ZONING BOARD OF APPEALS APPLICATION
TOWN OF SIMSBURY, 933 HOPMEADOW STREET, SIMSBURY, CT 06070

Location of Property: 10 Cedar Glen Road, West Simsbury, CT 06092
(number and street name)

PROPOSED ADDITION
10 CEDAR GLEN
PROPERTY OF
CURTIS LOONEY & MANU SINGH-LOONEY
SIMSBURY, CONNECTICUT

Letter from Architect

REAR ELEVATION
SCALE: 1/4"=1'-0"

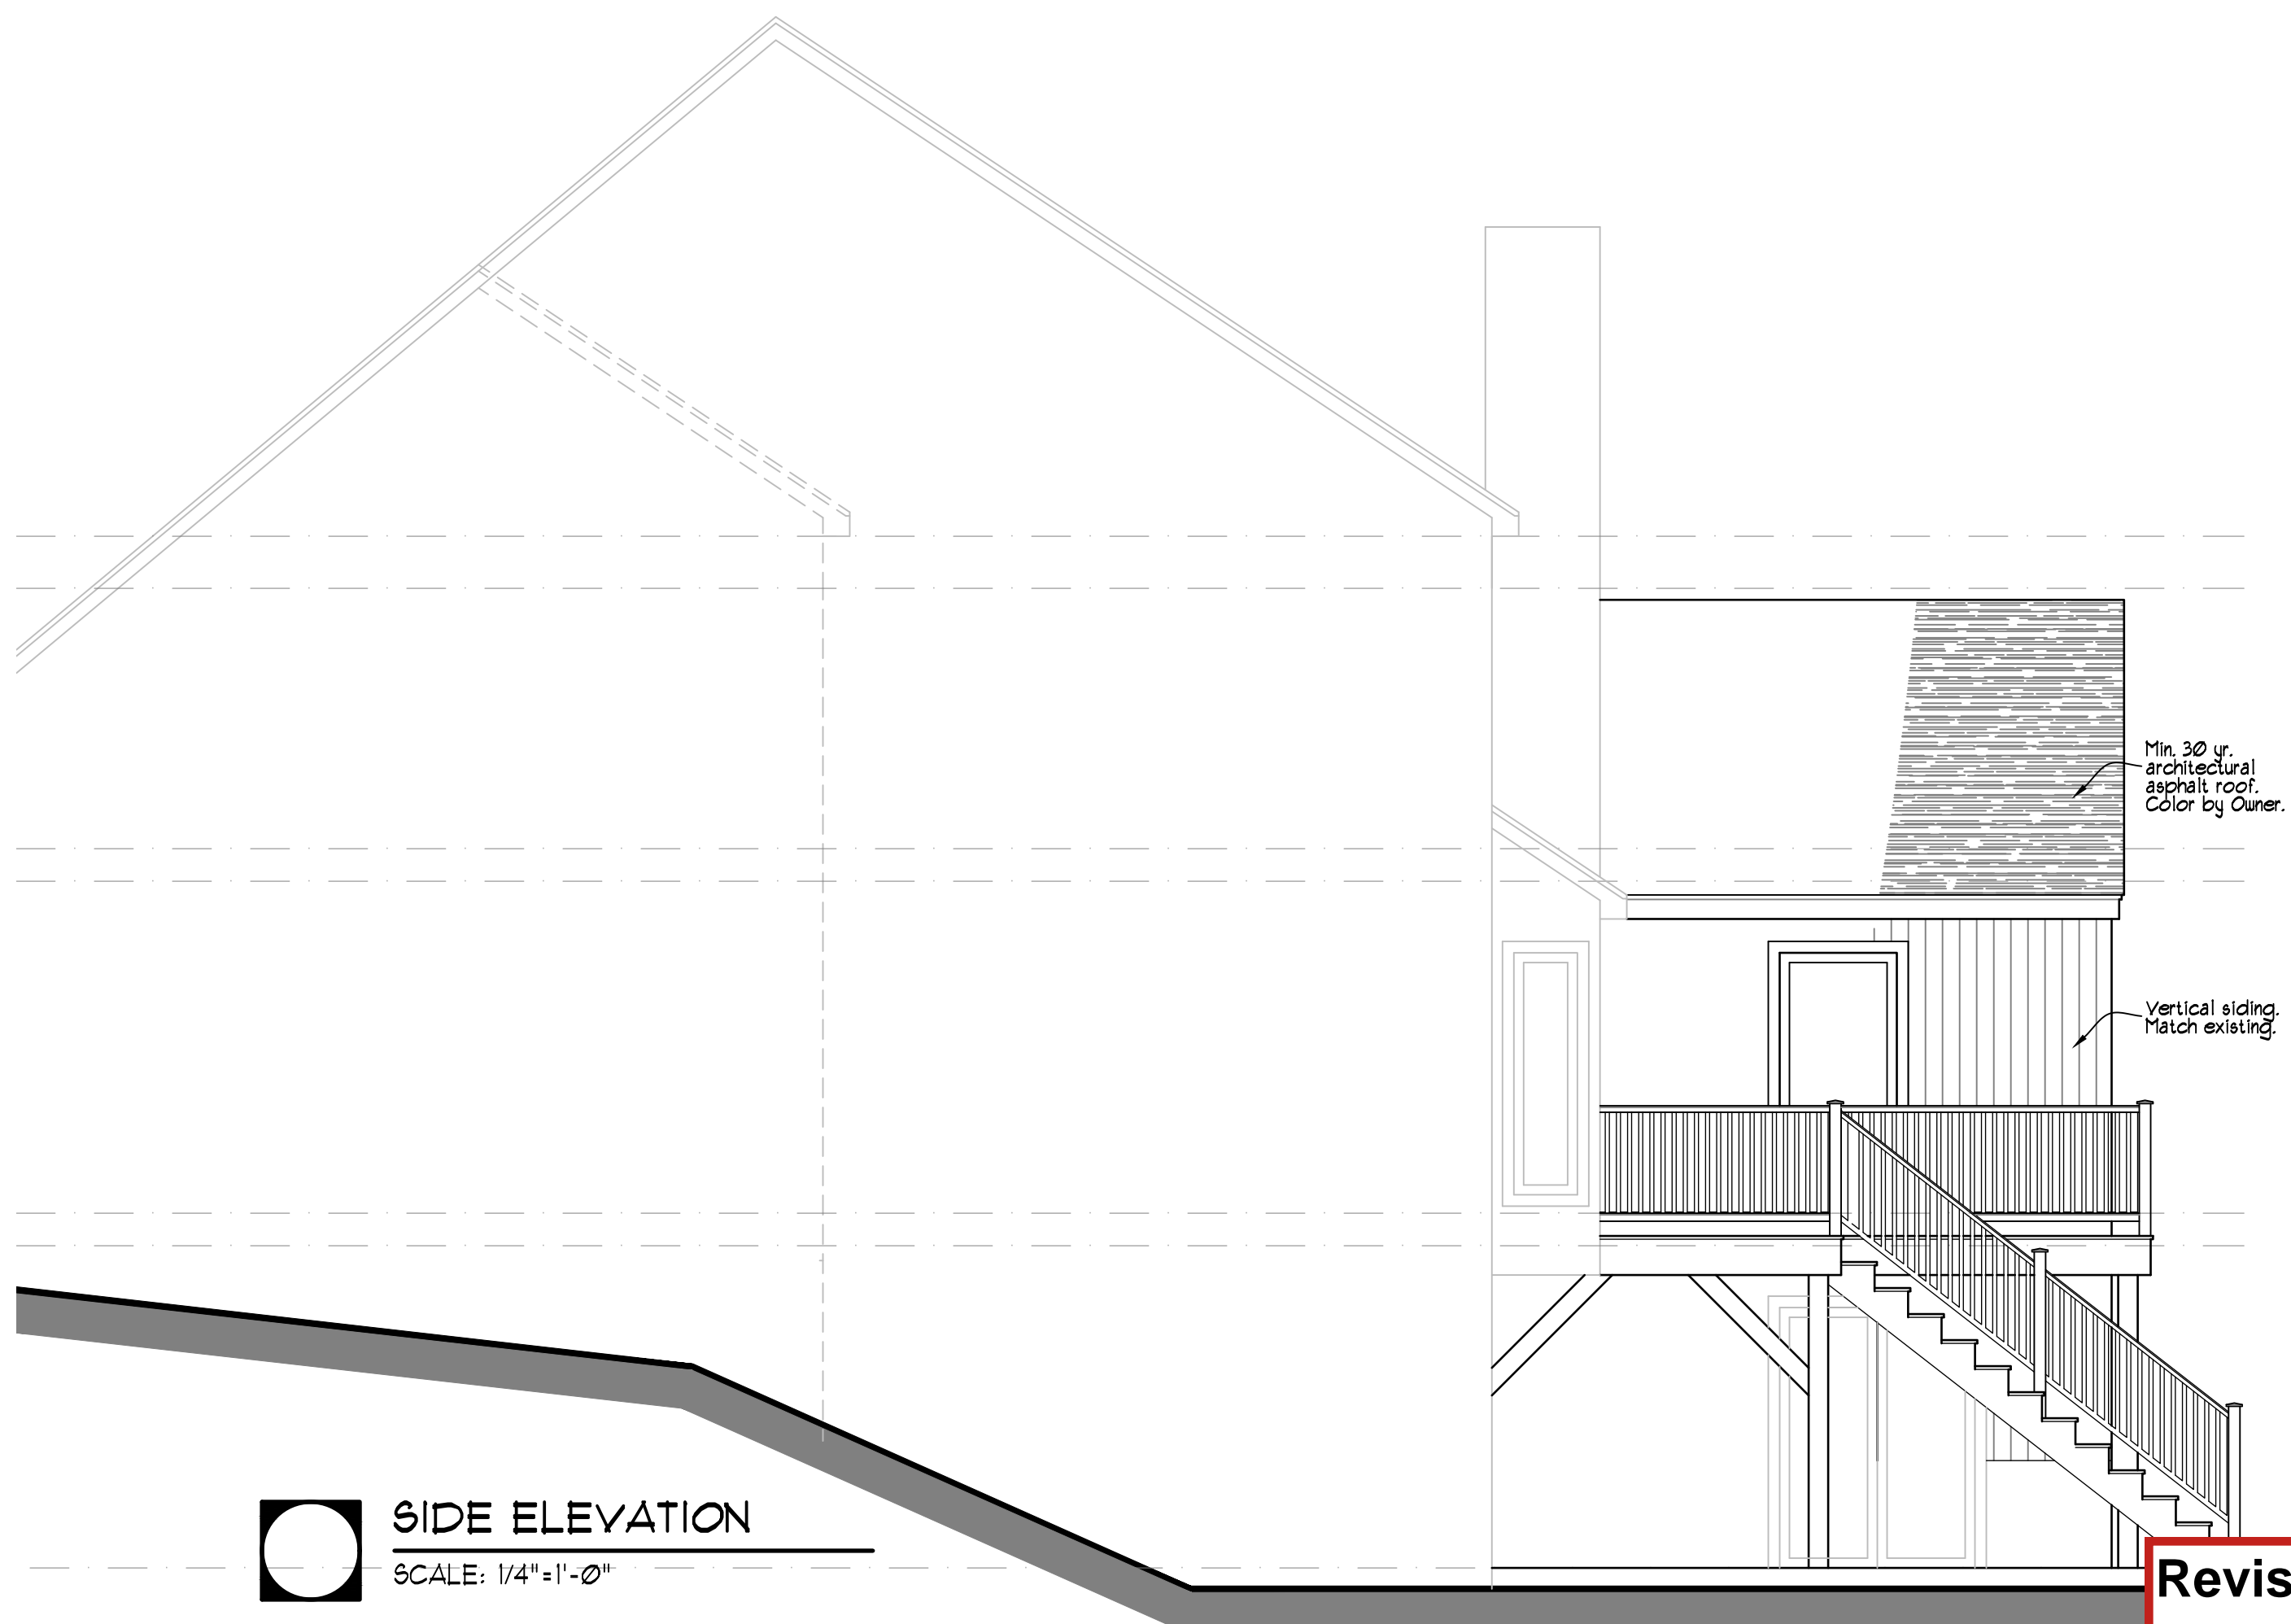
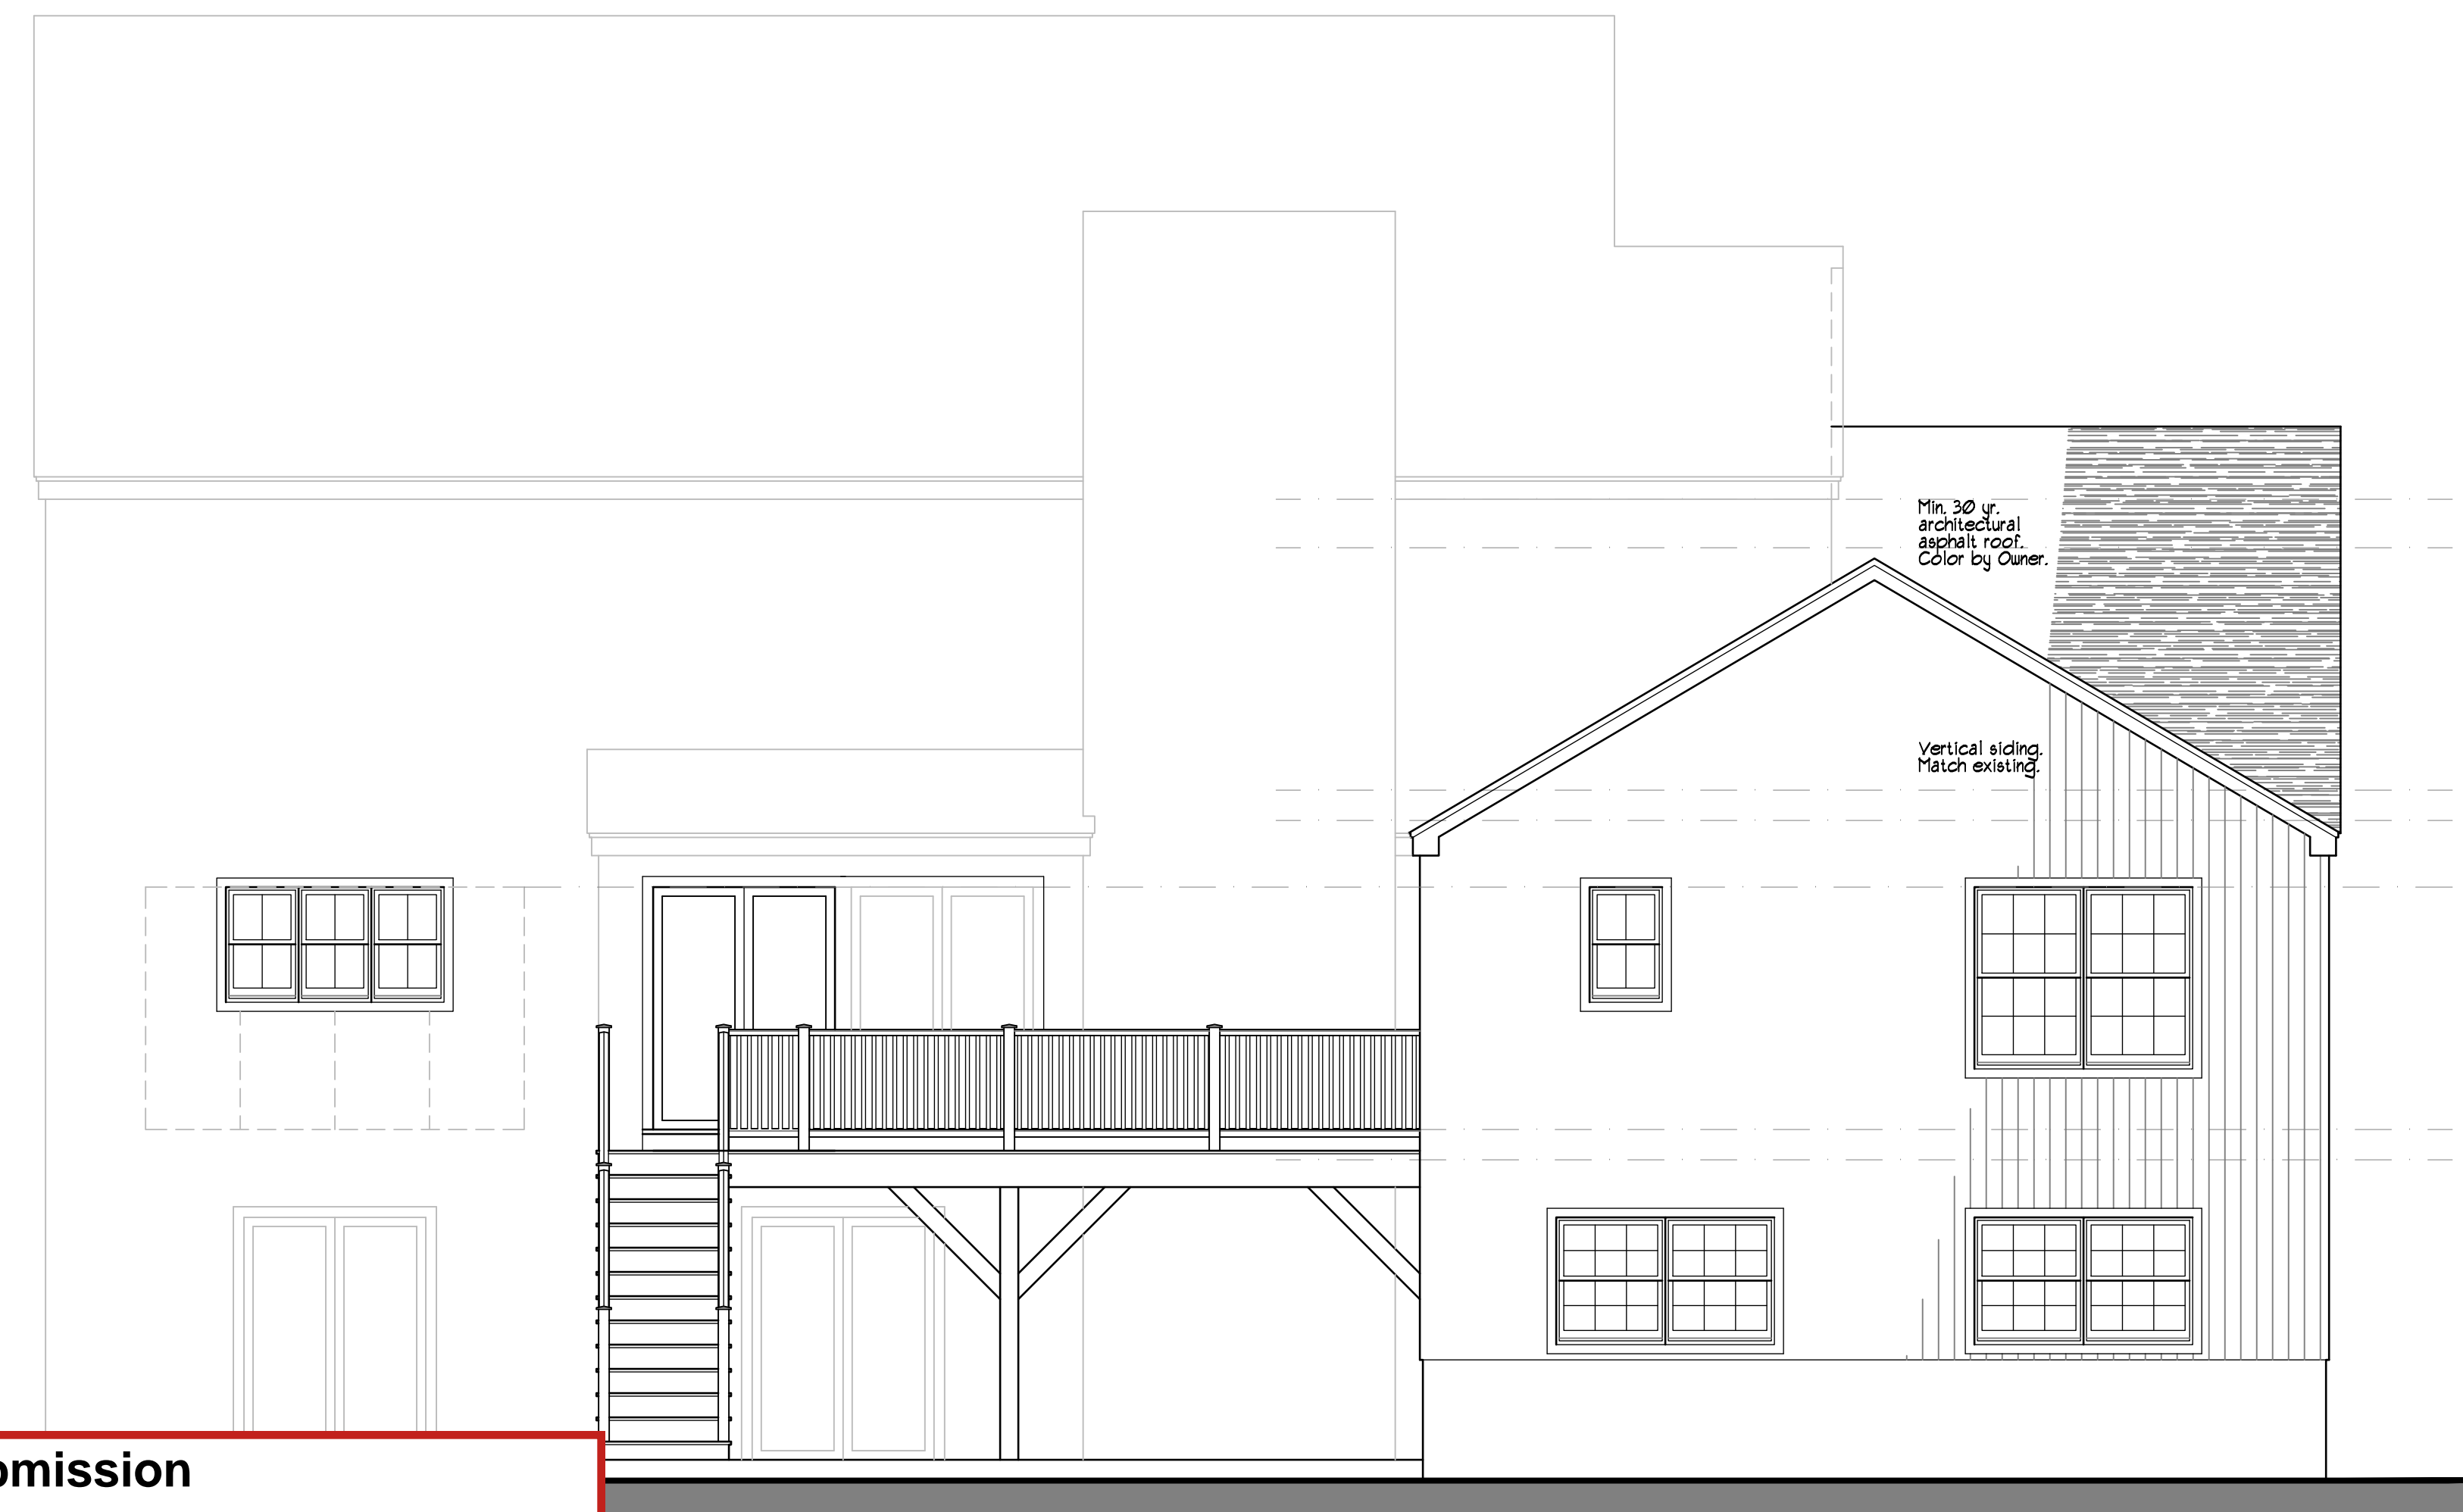
Revised Submission
Changes:
Door removed to the right of the garage.
Addition depth reduced.
